SCUBAPRO

Technical Service Schematic

MK 5 FIRST STAGE 10-105-000

Date 12/97 Revision V
Annual Repair Parts Kit #10-105-041

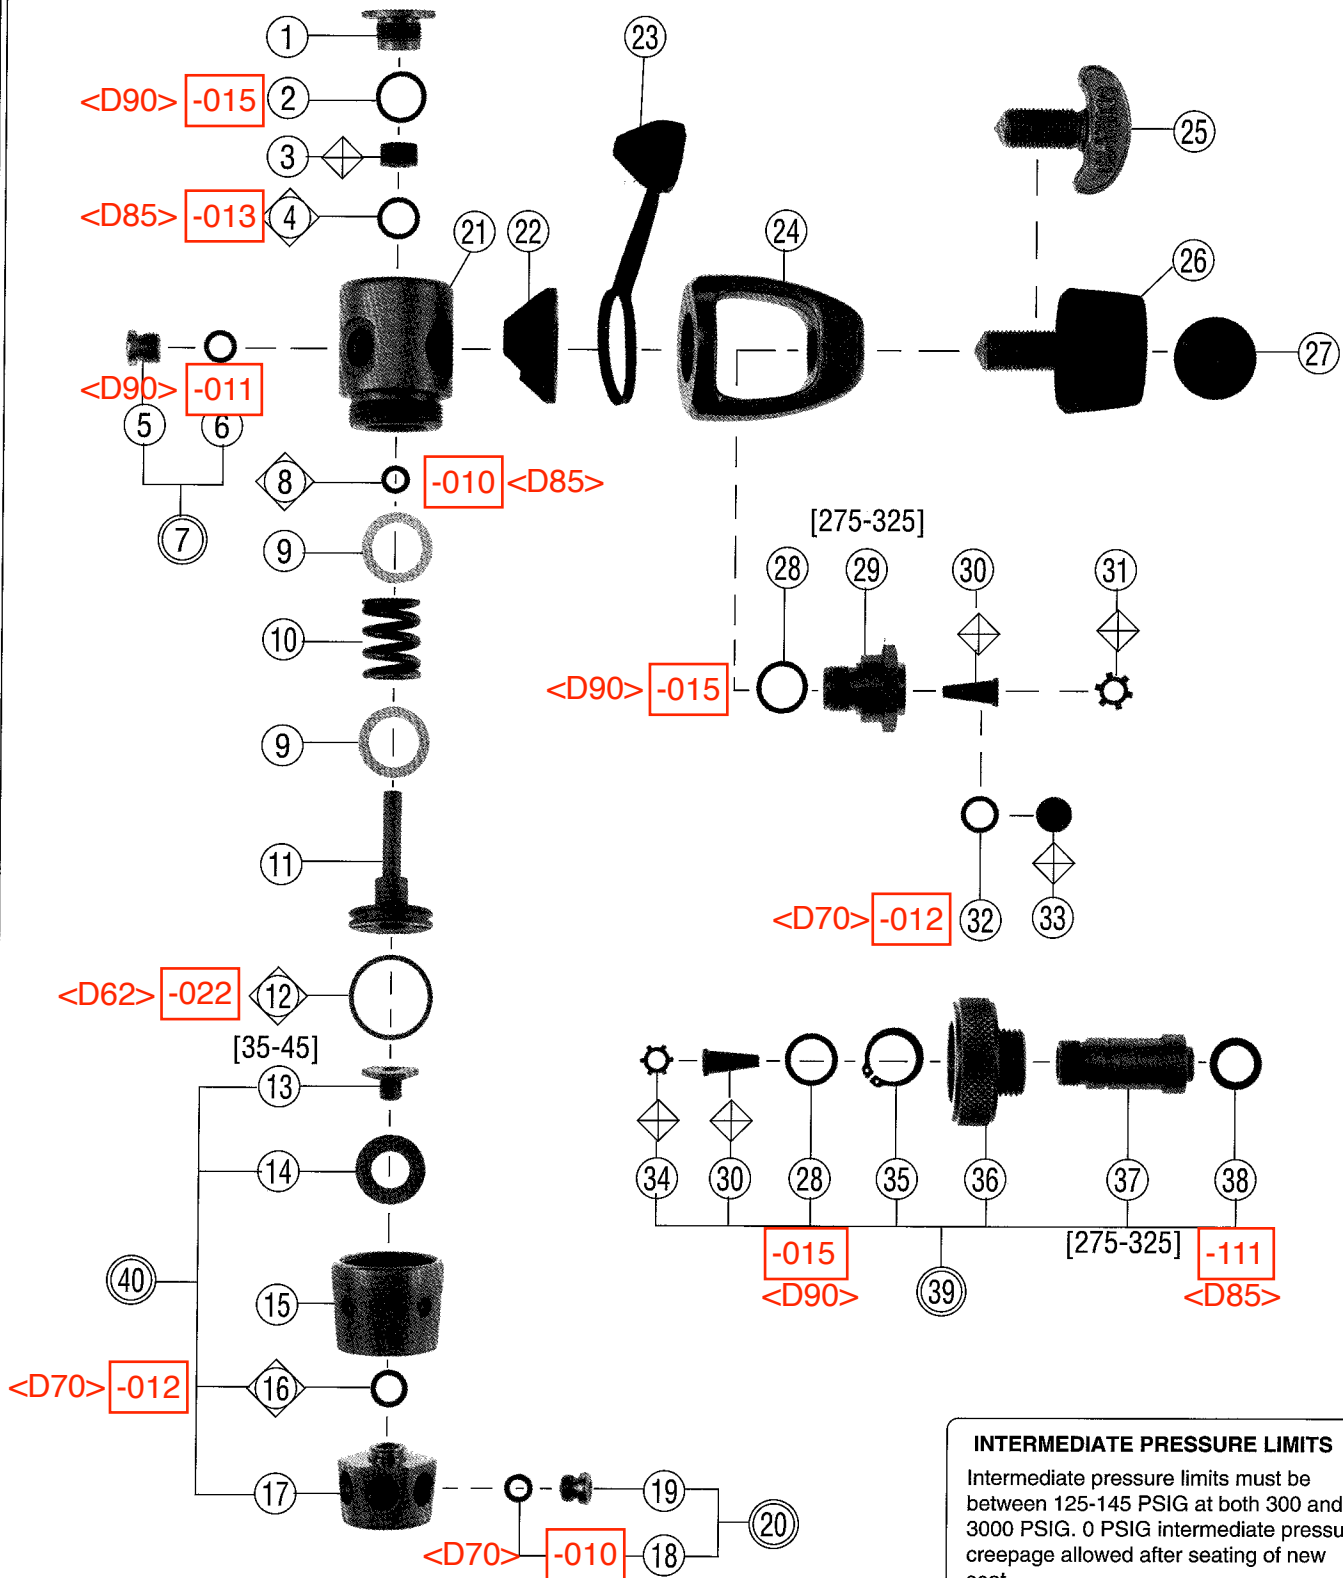
Item #25 note: This style yoke screw (9/16 thread) is an older configuration and is acceptable for 3000 psi service. The smaller thread size (3/8 and 7/16) yoke screws not shown are for older configuration MK5 yokes which are limited to 2475 psi service, and no longer available. These yokes and screws should be upgraded to the current configuration.

Flow through piston designs will under some conditions make a whistling noise during flow. To alleviate , replace Item #3 HP seat, and heavily lubricate Item #8. 01-050-137 o-ring.

Item #13 note: This part has been changed from brass to stainless steel. Replace any brass parts with the stainless design. Brass can be identified by the slight greenish color if corroded, or by scratching the surface to reveal the brass color beneath the chrome plating.
